ADDENDUM NO 1

Project Name: DOC CCF Boiler #1 Replacement Project

**DOCUMENT 00 9111
ADDENDUM NO. 01**

PROJECT NAME: IA DAS - DOC CCF Boiler #1 Replacement Project

A. SHEET S1.01 – STRUCTURAL FRAMING PLAN, DETAILS AND NOTES

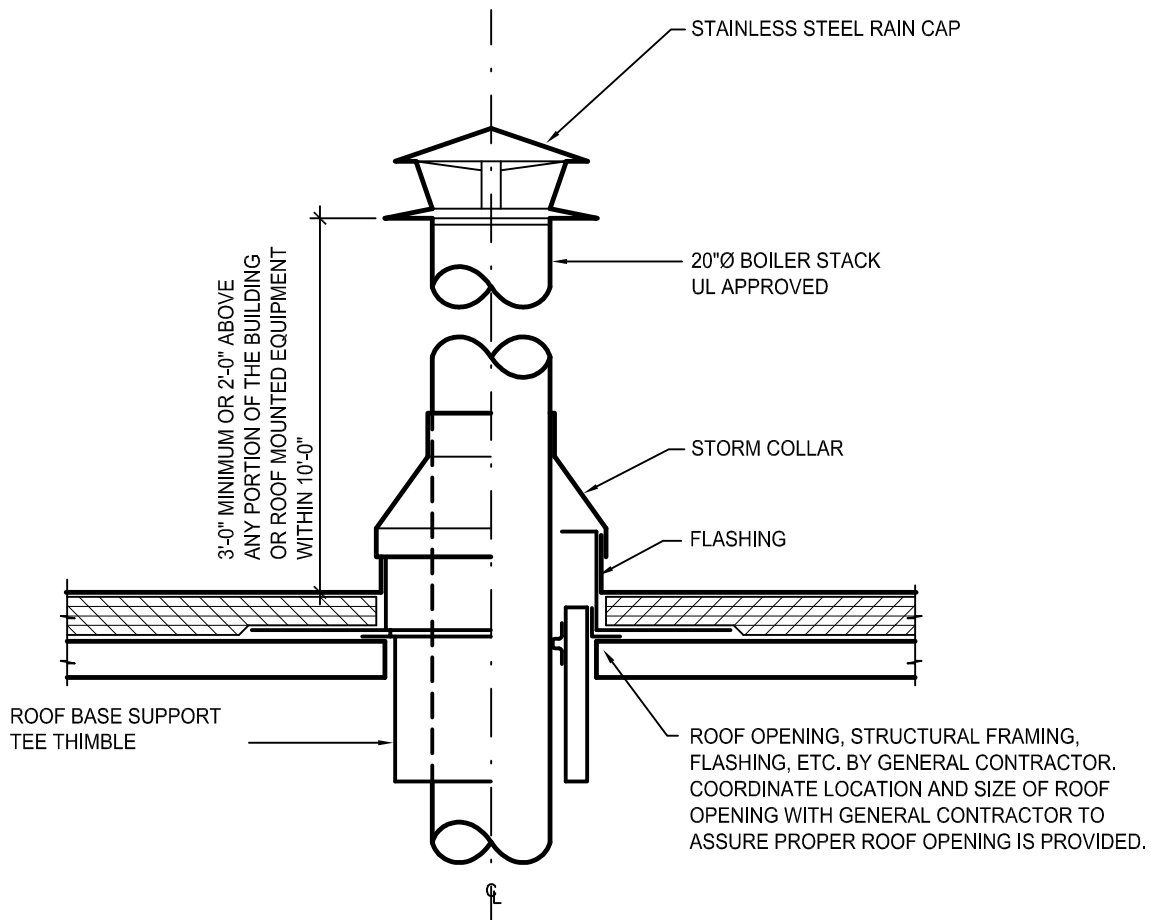
- i. Catwalk Framing Plan: **ADD** the following note:

“There is a short section of existing guardrail on the noted catwalk (about 4 foot long) which is just taped into place. Replace this taped-in section with matching guardrail (top and intermediate rails) with rail permanently welded into place. Add a vertical guardrail post in this vicinity, also permanently welded into place. Match existing adjacent verticals.”
